**ADDENDUM NUMBER 5**

- 1.01 DATE: MAY 19, 2021**
- 1.02 PROJECT: RENOVATIONS TO BUCHANAN HALL PHASE II**
- 1.03 PROJECT NUMBER: DCM NO. 2021305**
- 1.04 OWNER: ALABAMA A&M UNIVERSITY**
- 1.05 ARCHITECT: NOLA | VAN PEURSEM ARCHITECTS, PC**

SHEET NUMBER  
**E-3.1**  
OF

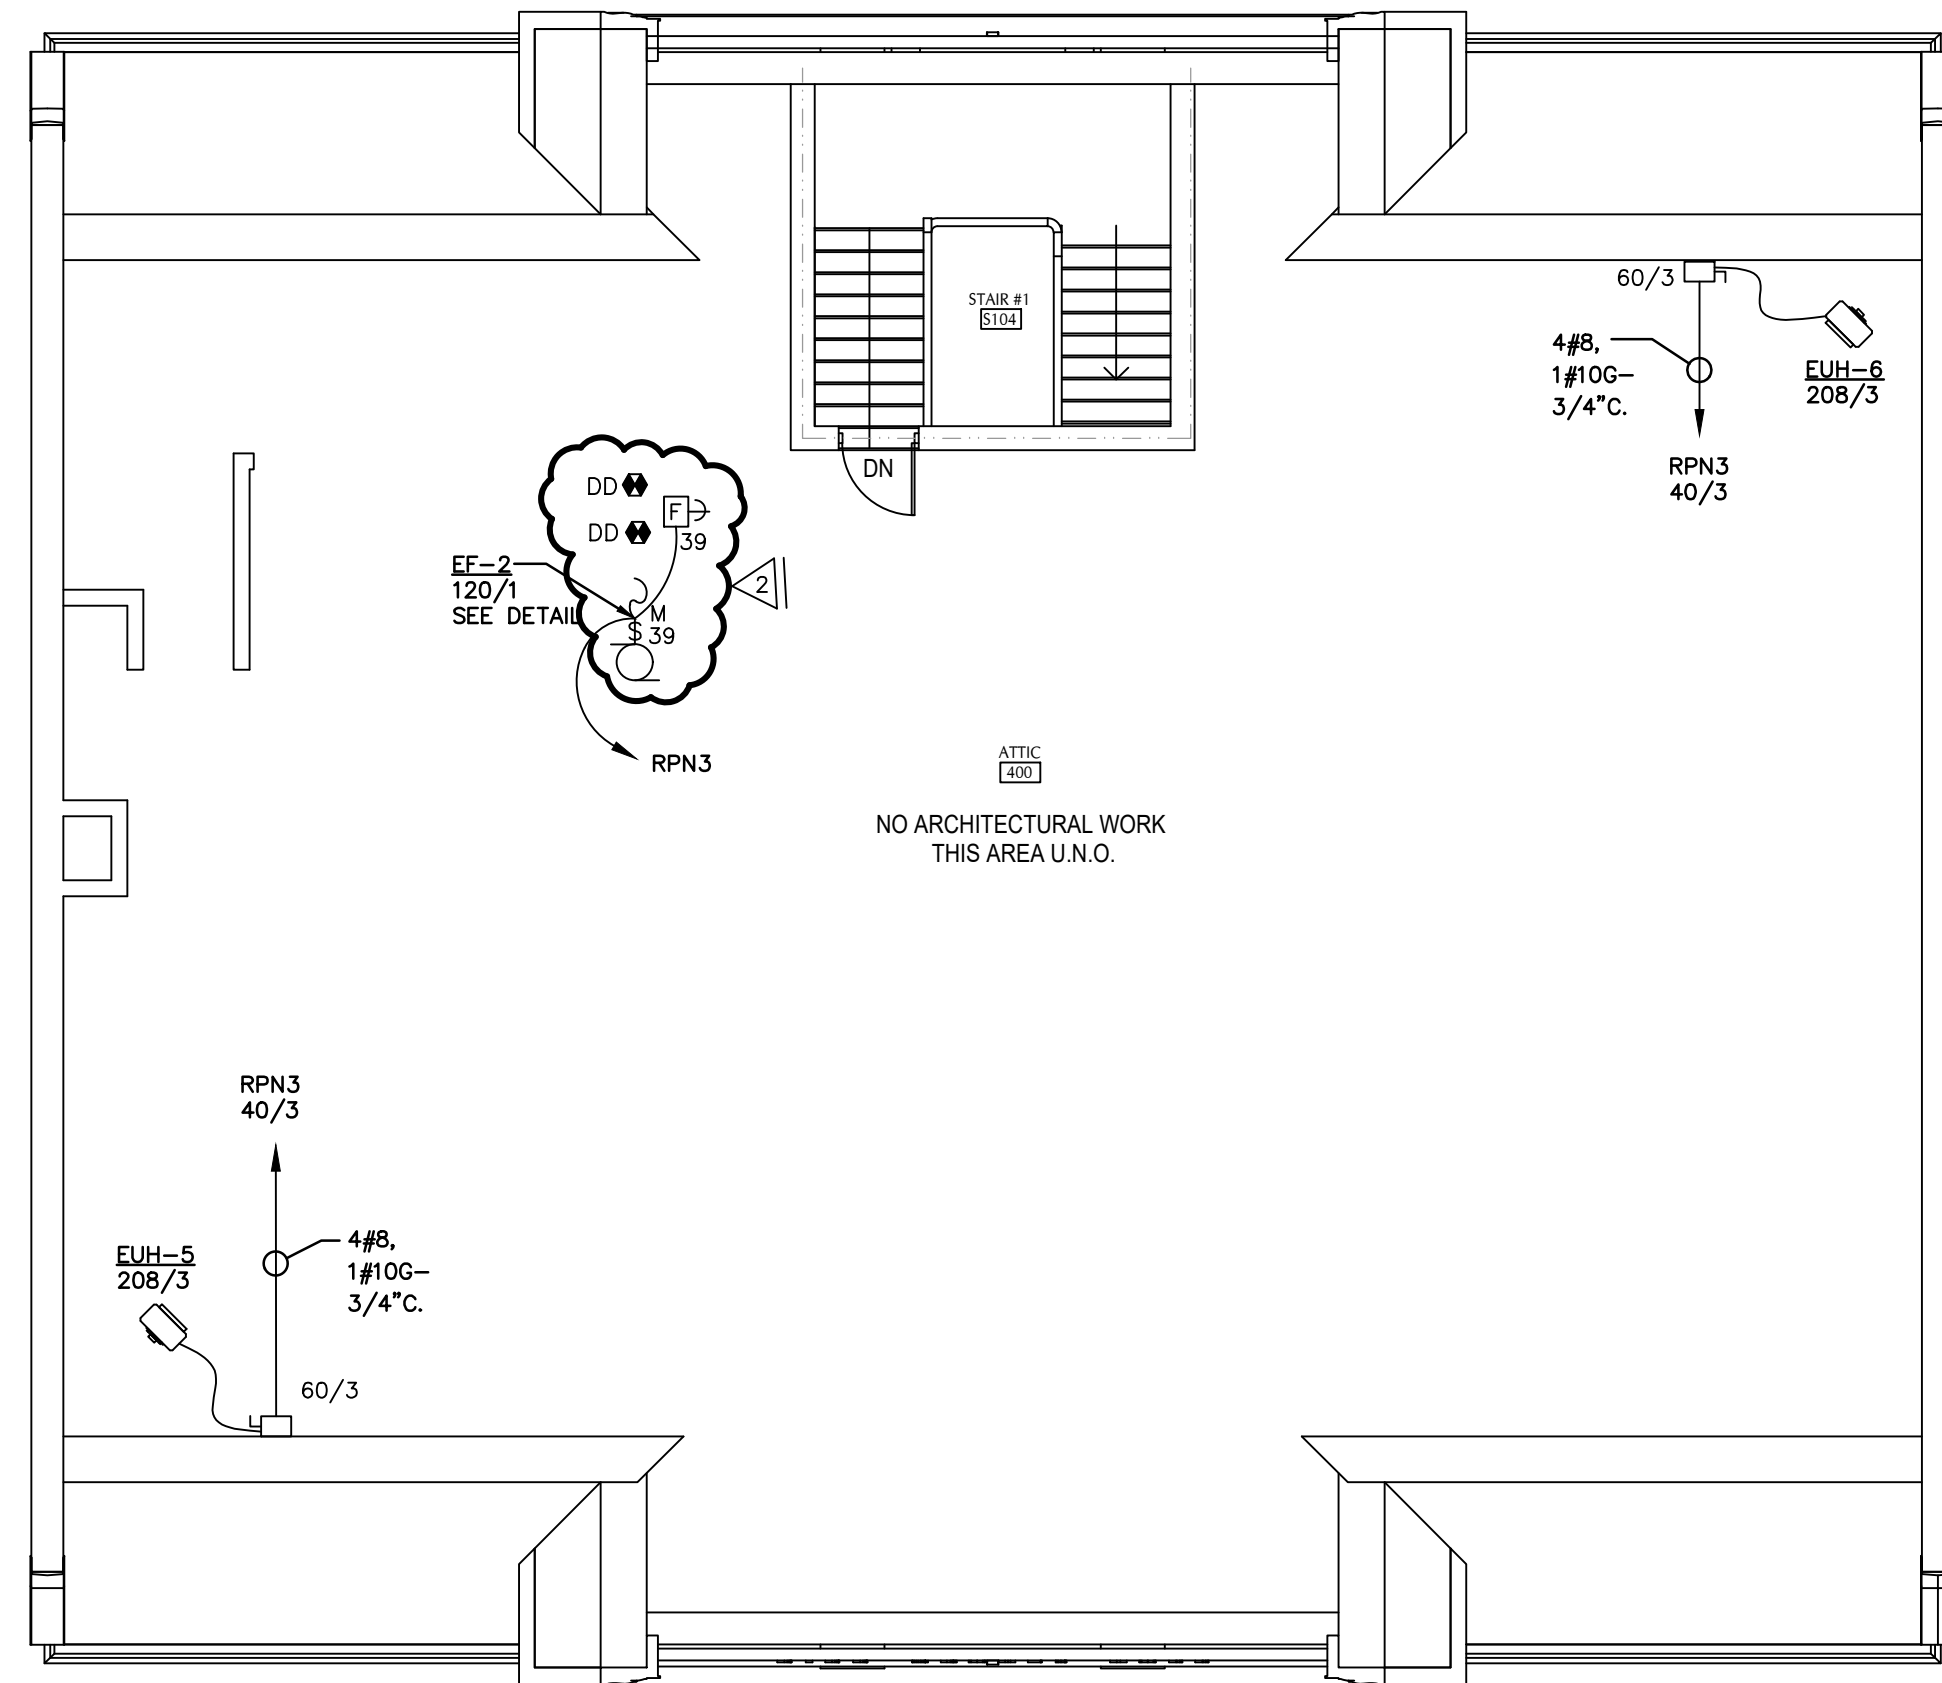
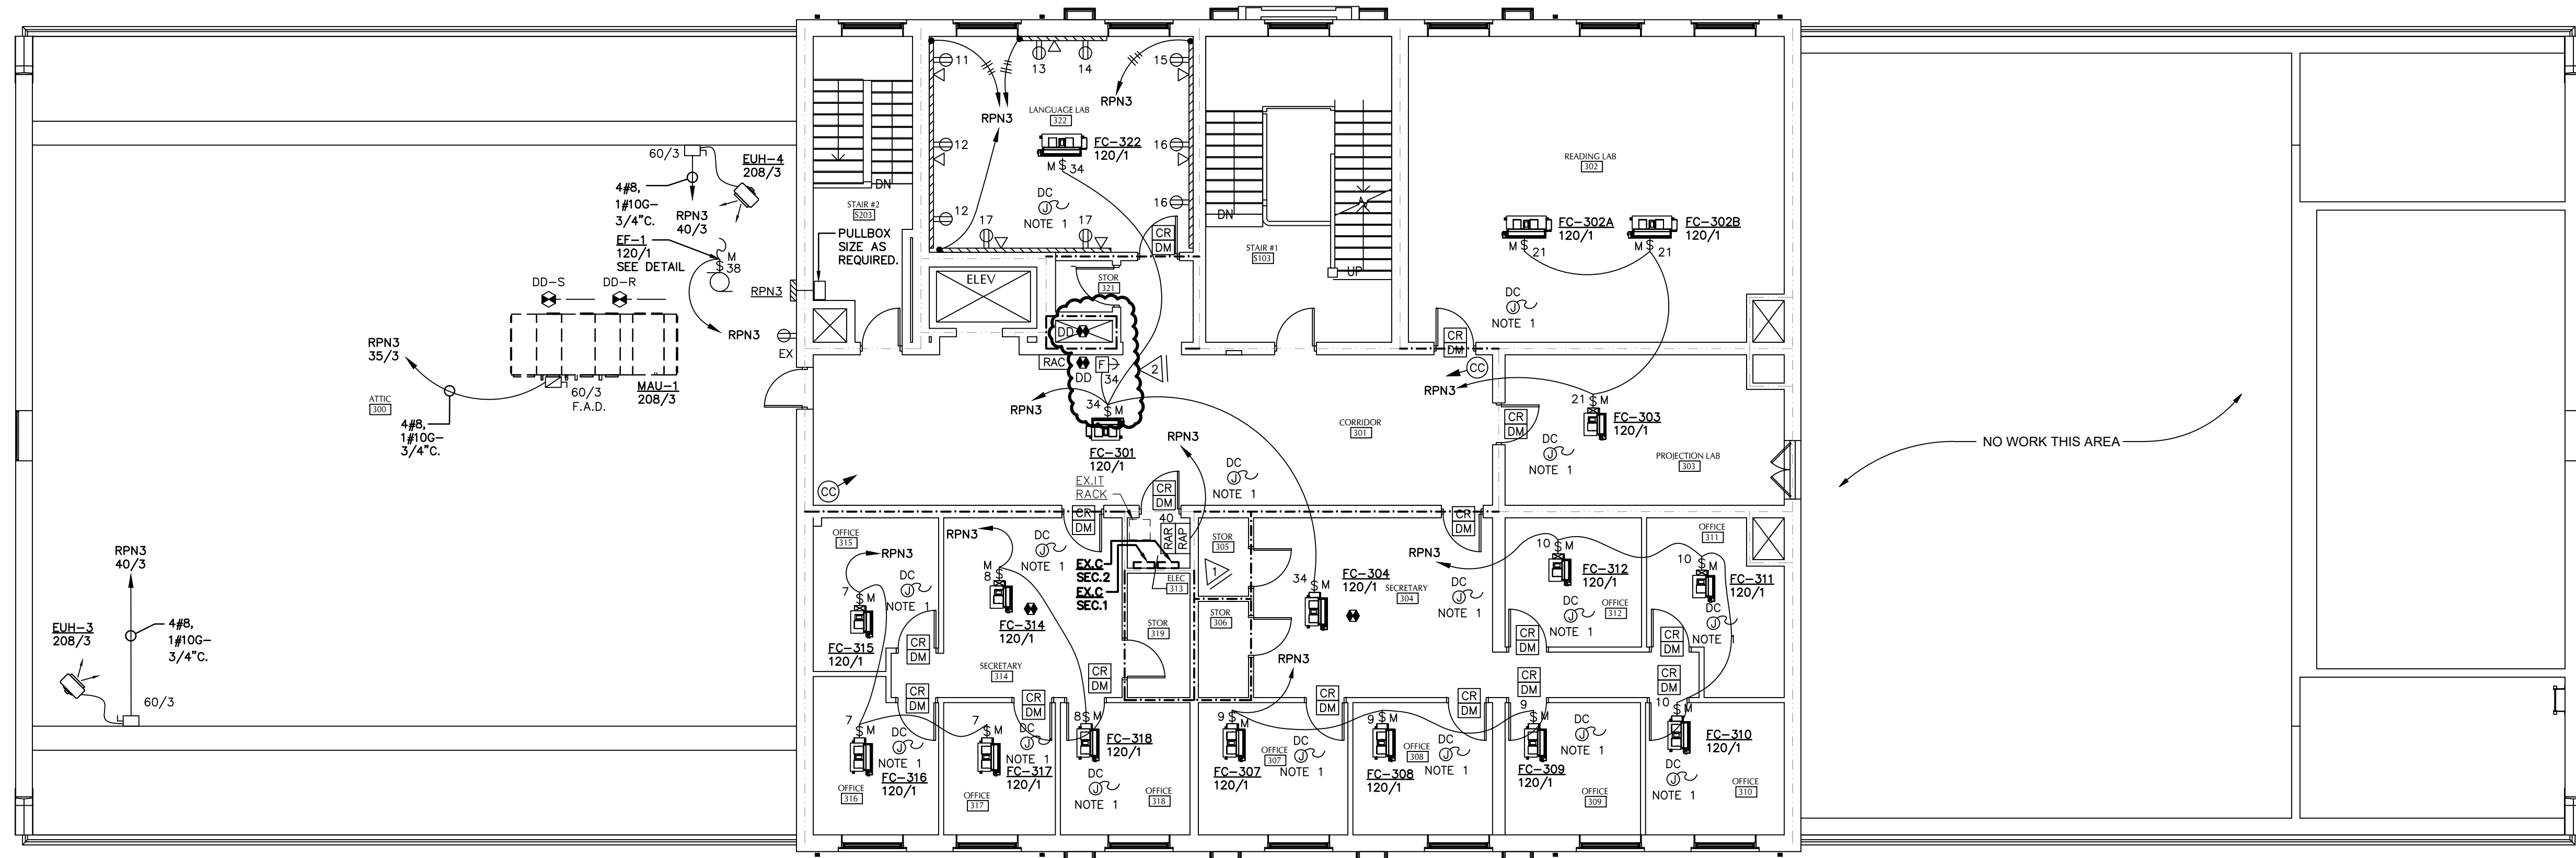
**4.09 SHEET E-3.1 - ELECTRICAL THIRD AND ATTIC PLAN – POWER AND AUXILIARY:**

- A. Replace this sheet in its entirety. Revisions include:
  - 1. Added motorized damper and duct detector in locations indicated.
